MEETING NOTICE – SITE REVIEW COMMITTEE

Date/Time: Wednesday February 23rd 2022 (5:30 P.M.)

RE: 550 Centennial Centre Blvd., HB-3208; Wall Signage, Scott's Subs

RE: 565 Larsen Orchard Parkway, HB-3206; New 3,697 Square Foot Commercial Building

SOUTH ELEVATION

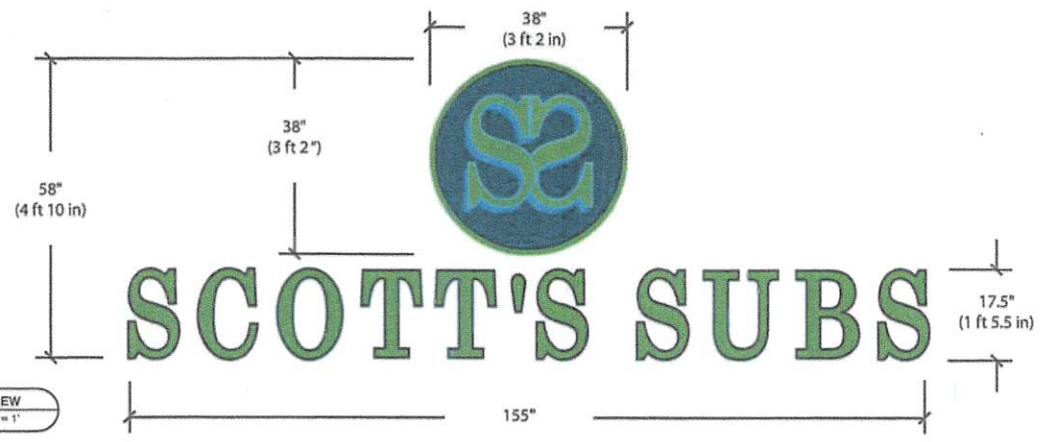
The approved plans back in October 2021 had signs proposed on three sides of the building and although this request is only for two of those same building elevations (south and west), Staff recommends including either of these two sign layouts to be possibly mounted on the east elevation as well. The request before the Committee at this time would be for a sign logo and channel letters of a total of 28.87 square feet on the south elevation (facing Centennial Centre Blvd.) and a logo only of 14.44 square feet on the west elevation (facing round-a-bout). All proposed signs are code compliant and will be internally illuminated with LED lighting. Per ordinance, 10% of the wall surface of each building elevation can be covered by signage so both wall signs would be in compliance with the Village Sign Code.

Staff recommends approval of the proposed 28.87 square foot wall sign to be mounted on the south elevation of the building, a 14.44 square foot wall sign to be mounted on the west elevation of the building as submitted and up to a maximum of 28.87 square foot wall sign on the east elevation of the building.

SITE PLAN

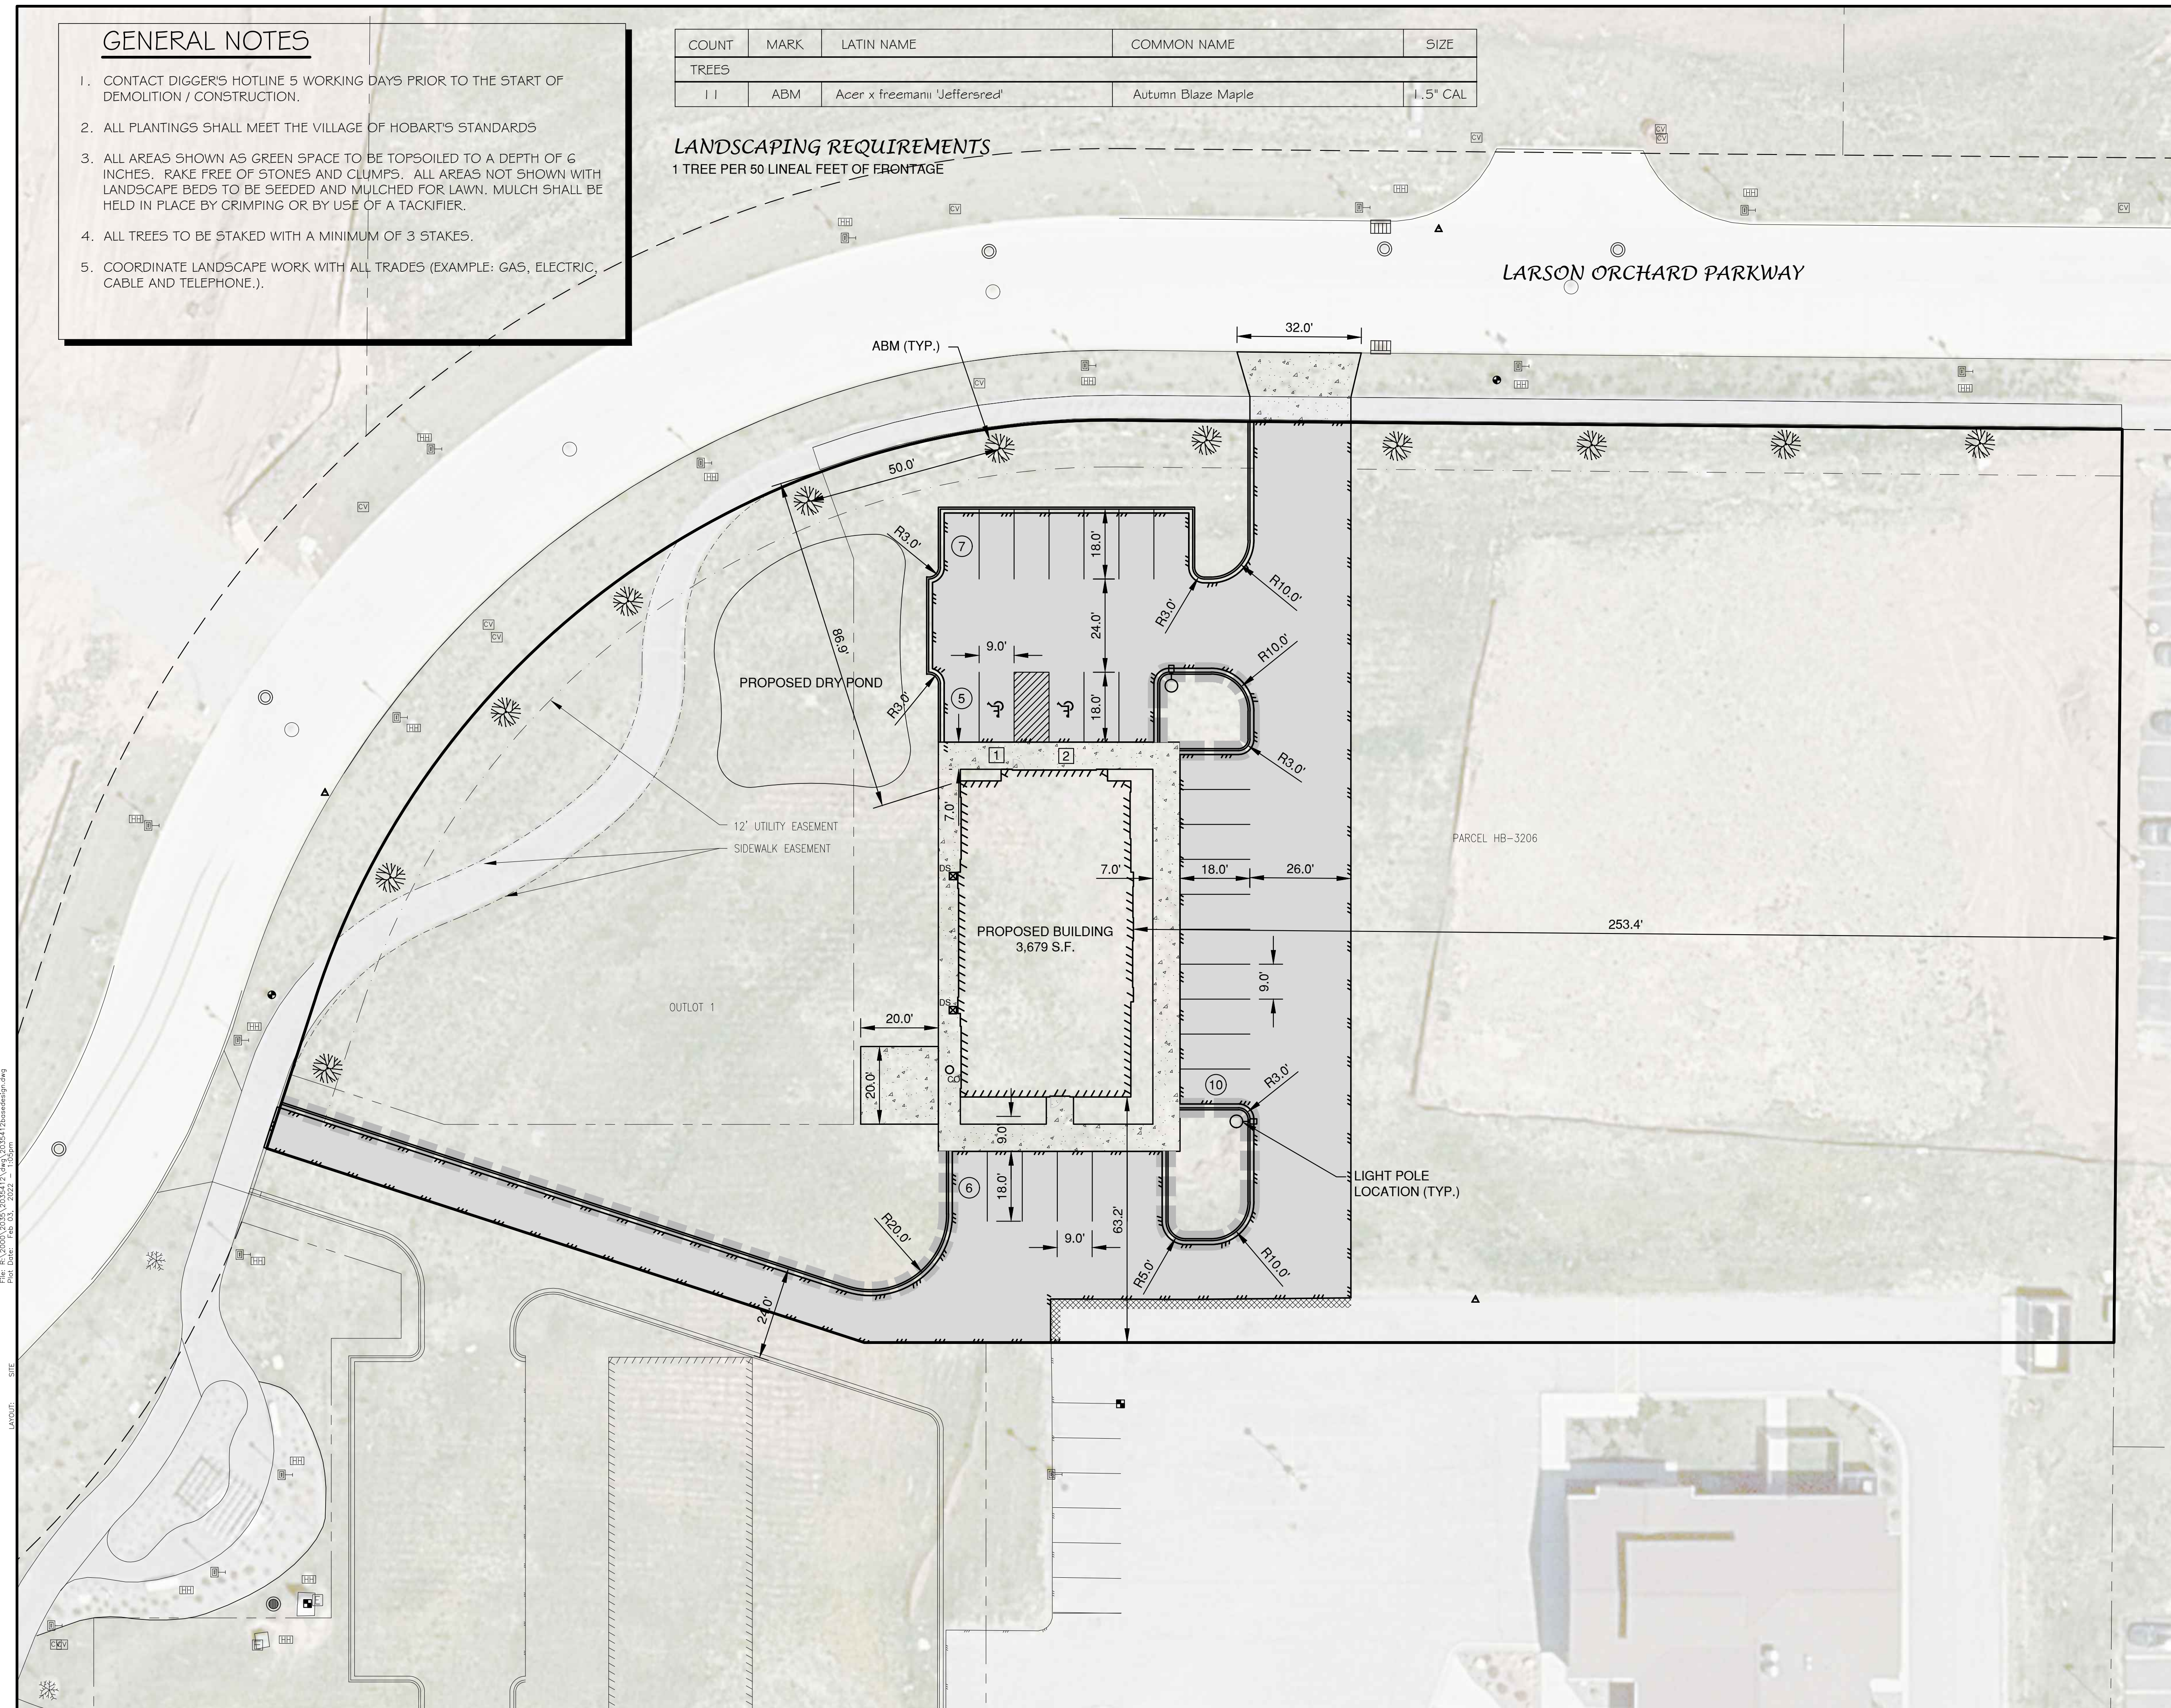
- A. Zoning:** PDD #1: Centennial Centre at Hobart District
- B. Green Space:** 72.7% green space proposed.
- C. Setbacks:** Per the PDD #1 zoning district, “minimum setbacks will be established per the design of the structure”. Front setback along Larsen Orchard Parkway – 85.9’ (to corner of building), 253.4’ to east property line, and 63.2’ to south property line. All comply with zoning requirements.

- D. Parking:** 28 spaces proposed, 18 spaces are required per code of 3 stalls per staff member (6 staff members proposed).
- E. Fire Dept. (and Police Dept.):** The plans presented have been reviewed and accepted by the Police Chief and Fire Chief.

- G. Refuse Collection:** No additional refuse/recycling enclosure is noted on the site plans. Must be verified that the plan is to utilize the existing enclosure along the south property line and shared with the development to the south.

Section 4, Lighting: Two parking lot light poles are noted in the peninsulas at the corner of the proposed building, however, no light details or building mounted lights is submitted at this time. Shall be submitted for approval prior to installation.

Section 6, Driveway-Curb Cut: A 26' wide driveway with a 32' curb cut is proposed along Larsen Orchard Parkway and a second ingress/egress will be through a shared location also along Larsen Orchard Parkway.

1. Detailed landscape plan shall be submitted for approval which includes landscaping around building perimeter, and screening for parking areas located in front of the building (along Larsen Orchard Parkway).
2. Details and locations of building mounted lighting and parking lot pole lighting shall be submitted for approval prior to installation.
3. Signage details shall be submitted for approval prior to installation.
4. Any mechanical equipment if located on the roof or ground, shall be screen from view by materials compatible with the building or landscaping.
